**ADDENDUM #001
ITB 5742-2023
Gilchrist Elementary School Millwork Replacement Project**

Date: May 23, 2023

Gilchrist Elementary School Casework Replacement For Leon County Schools

Interior Elevations
DRAWING NAME
Casework Elevations

A7.2

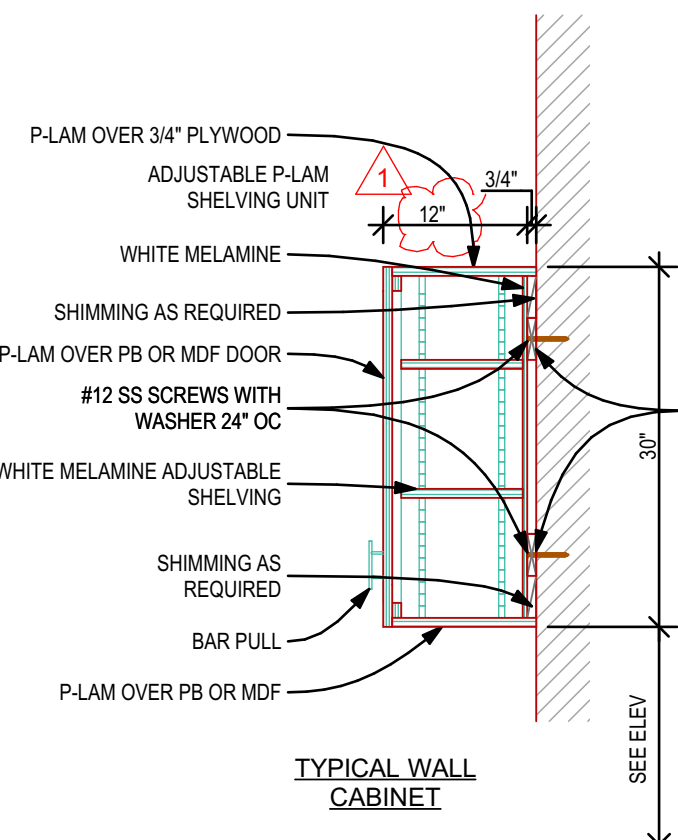
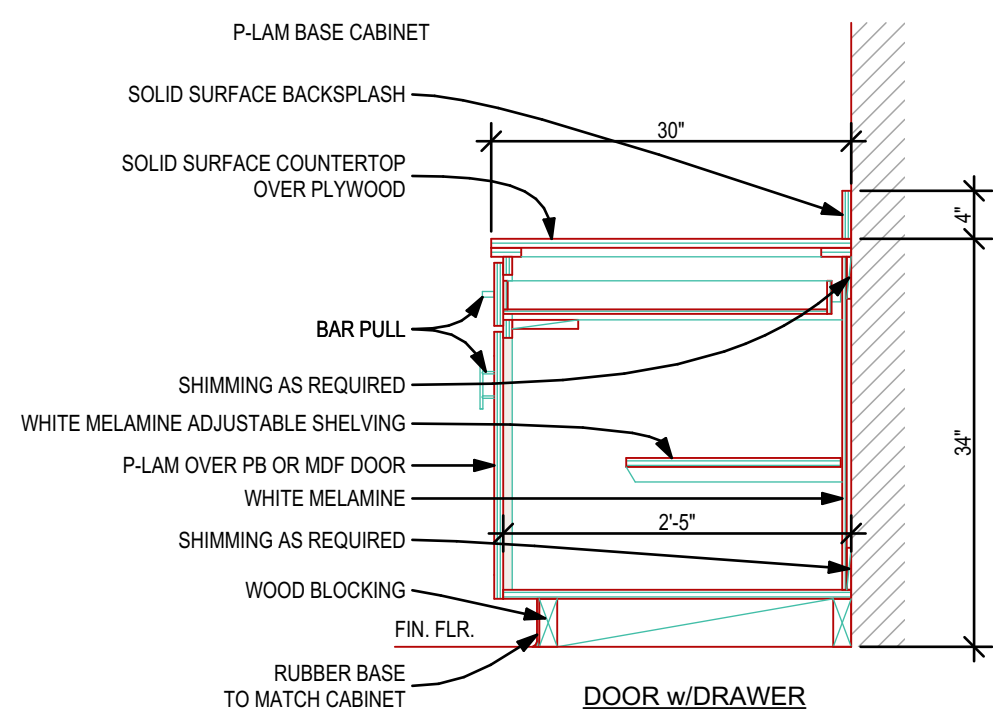
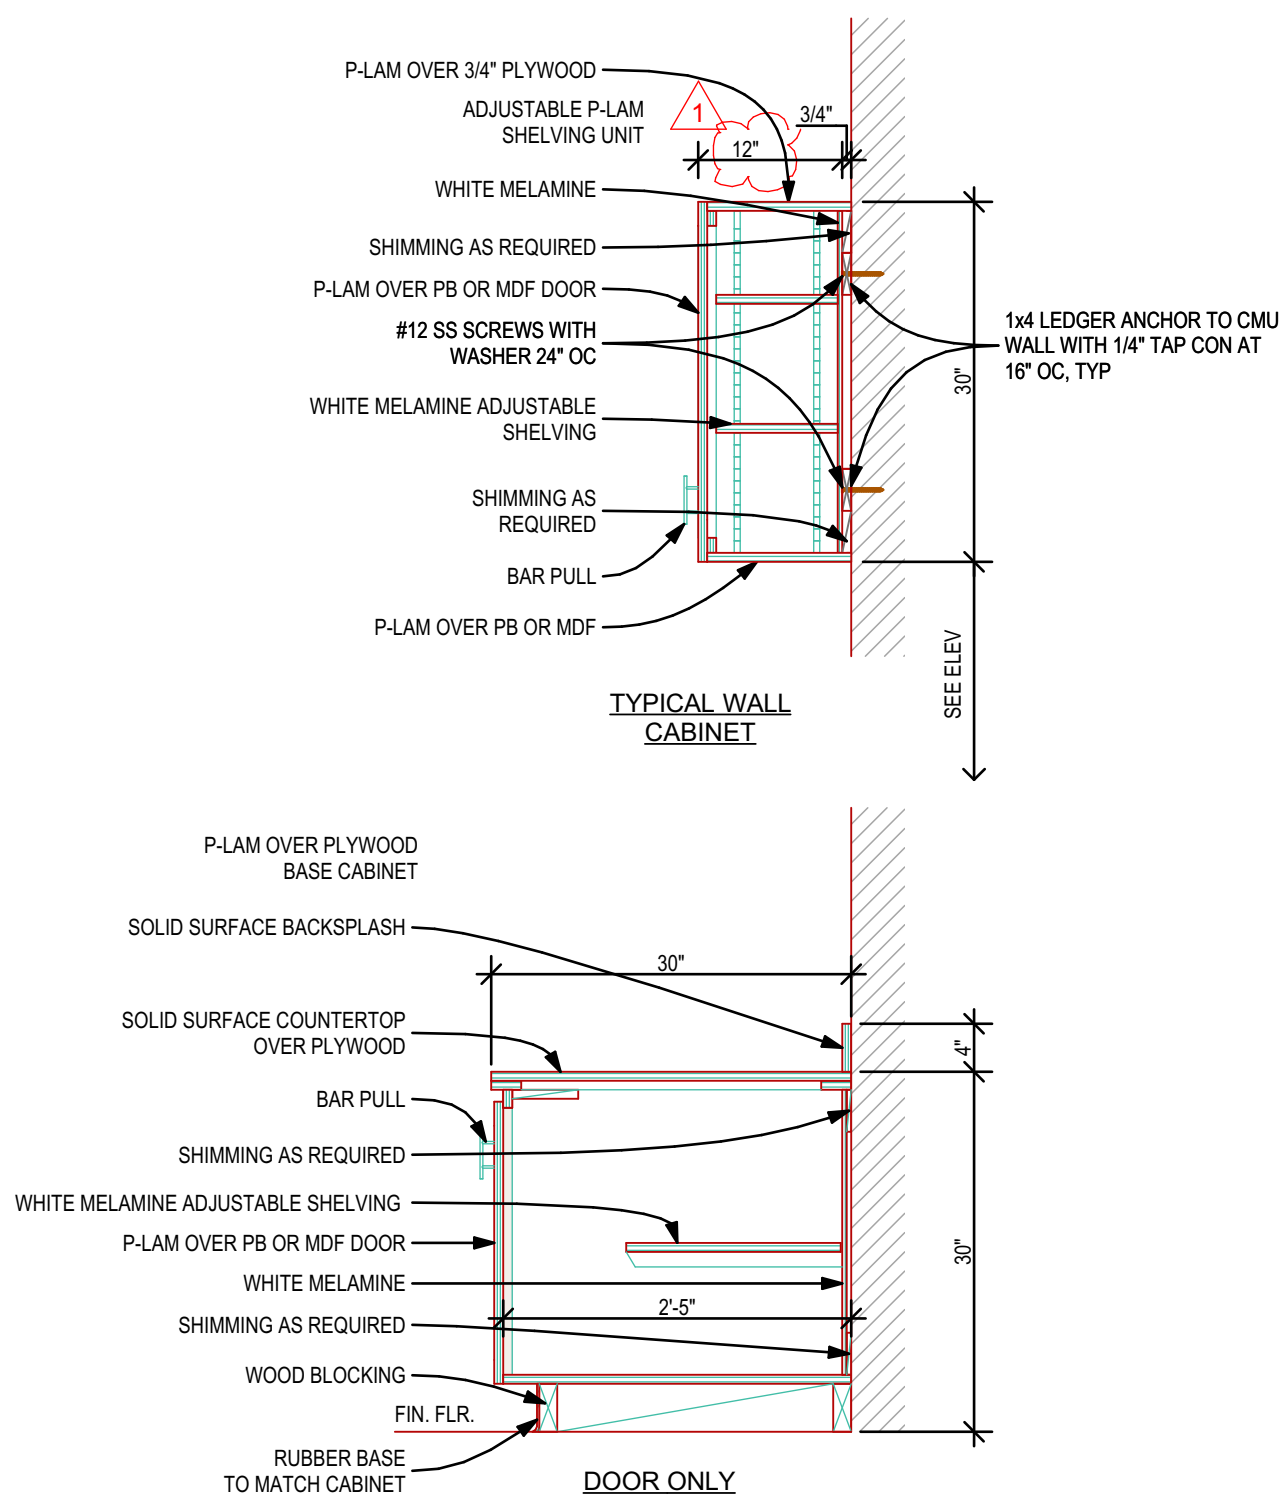
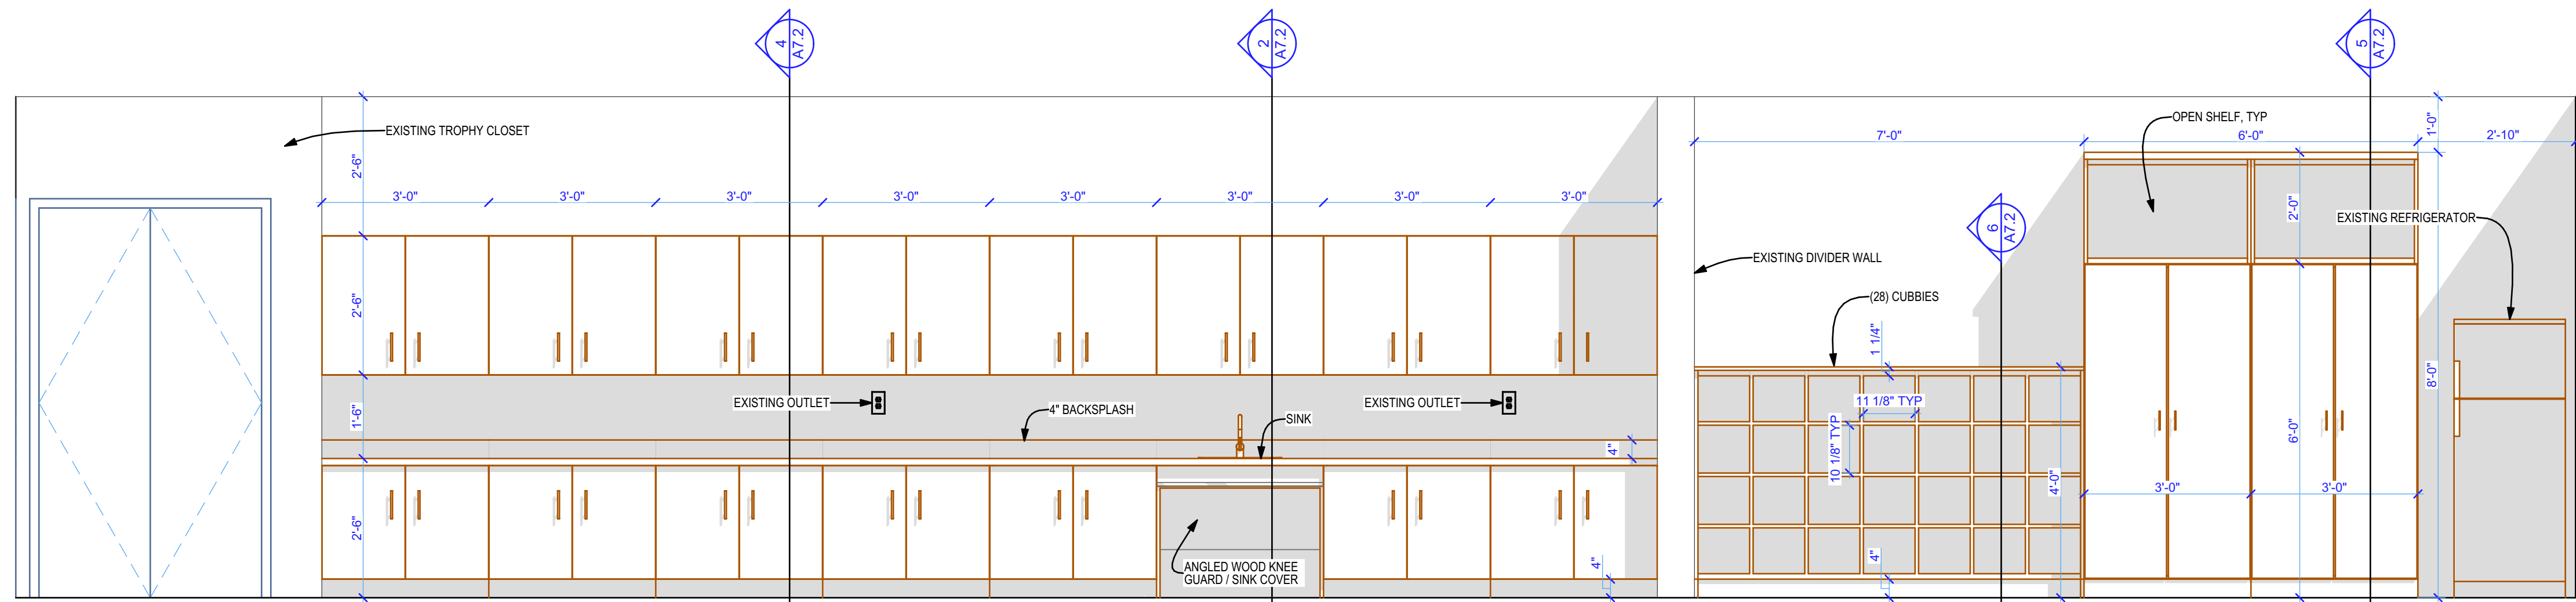
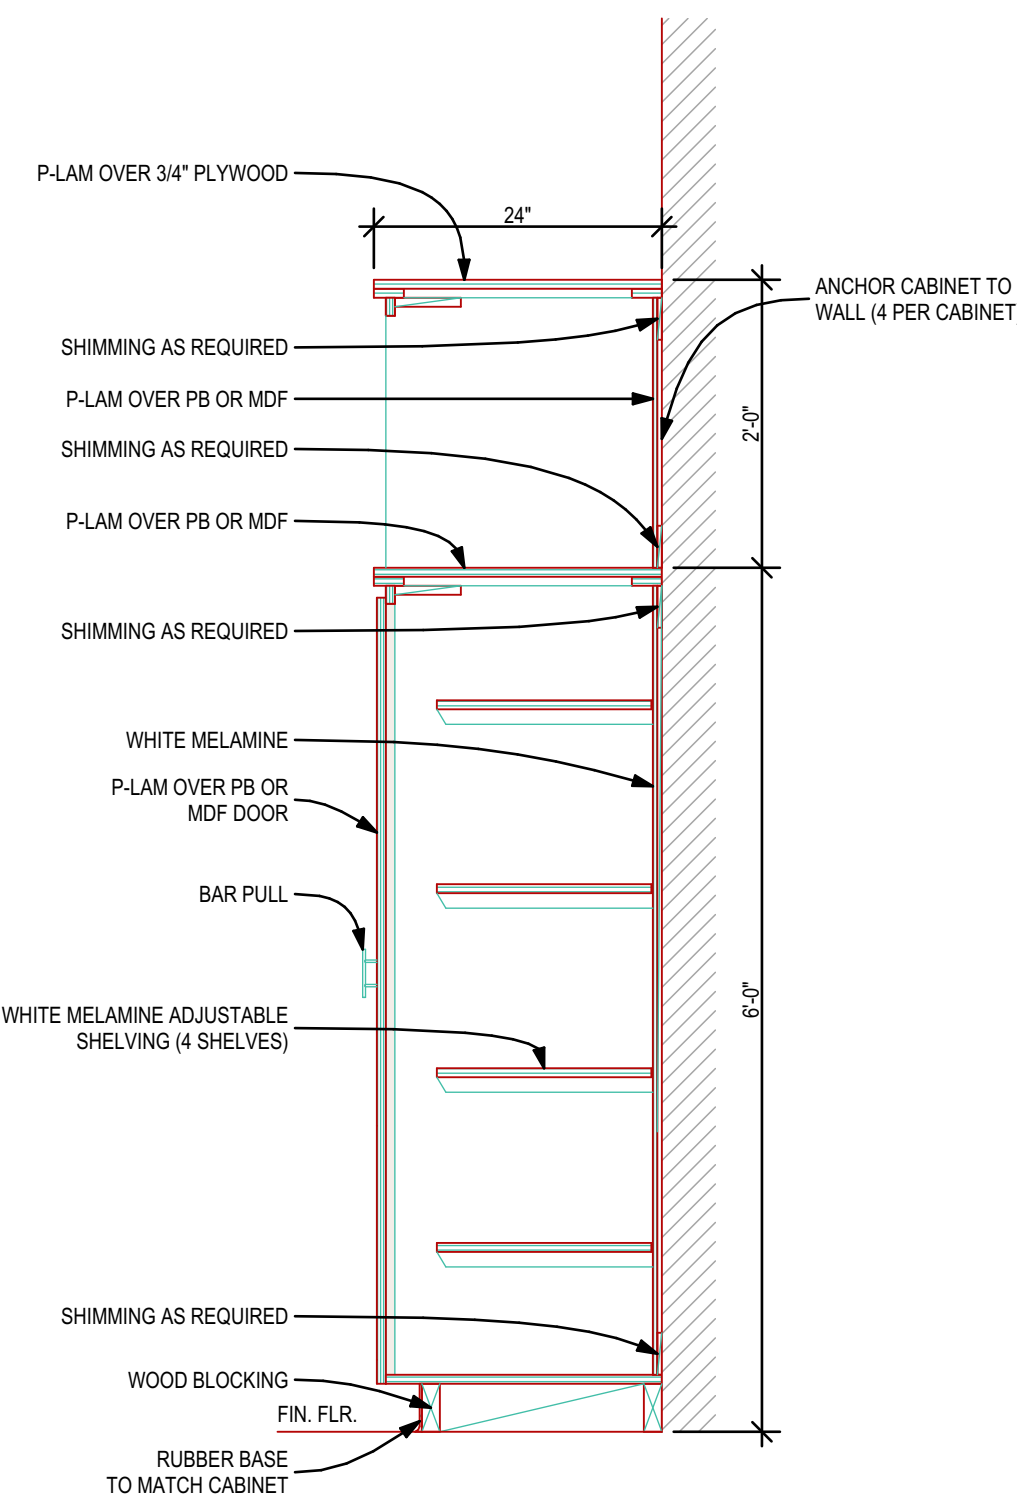
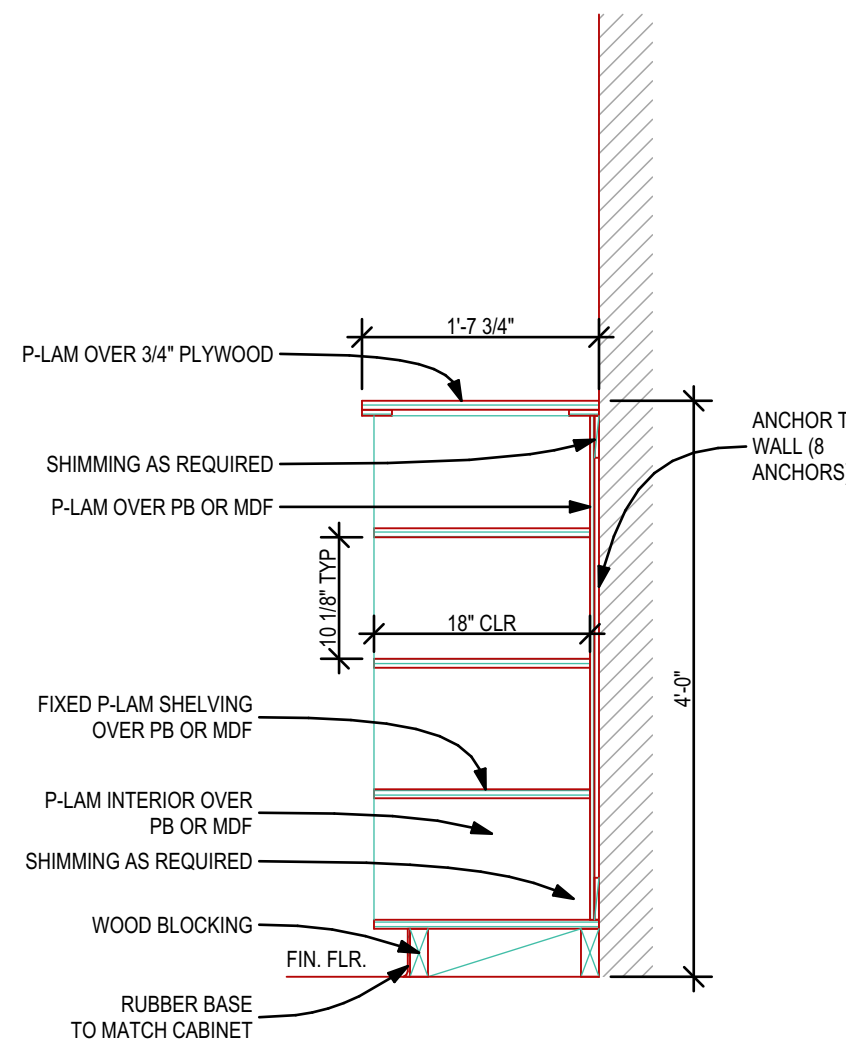
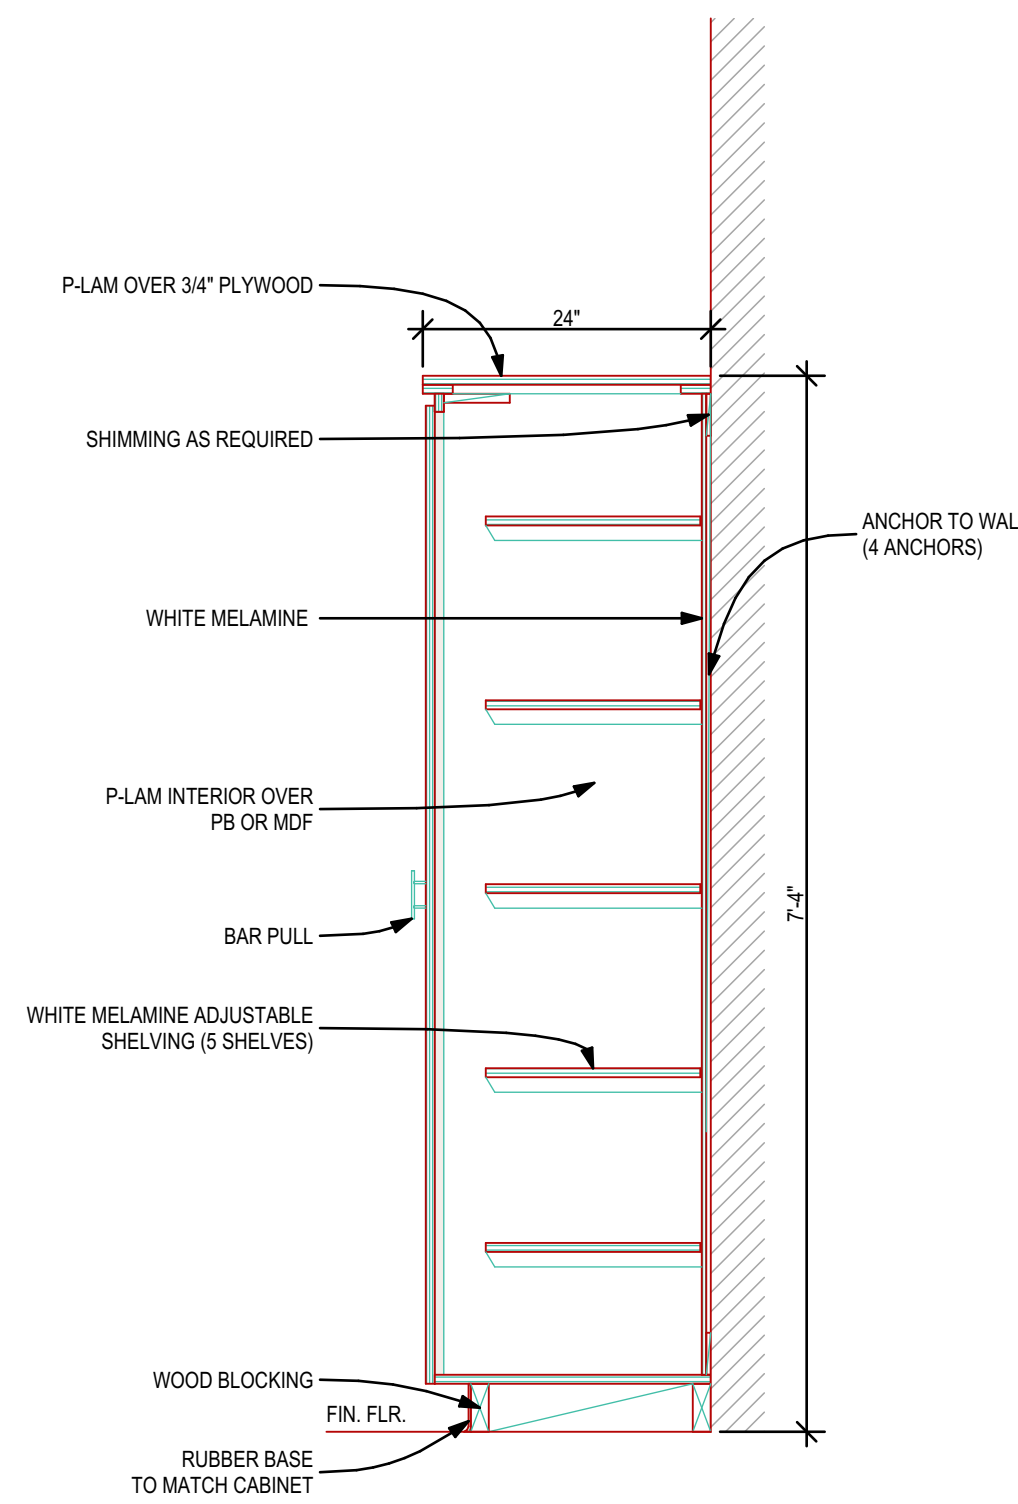
Answer:	The scope is correct.
2.	Upper cabinets shown in plans are 24" deep, is this correct? Typically upper cabinets are only 12" deep.
Answer:	Please see the revisions to the plans (Revised Sheet A7.2) in this Addendum #001.

Sheet A7.2 of the Exhibit 1 is deleted in its entirety and replaced with Revised Sheet A7.2, attached to this addendum.
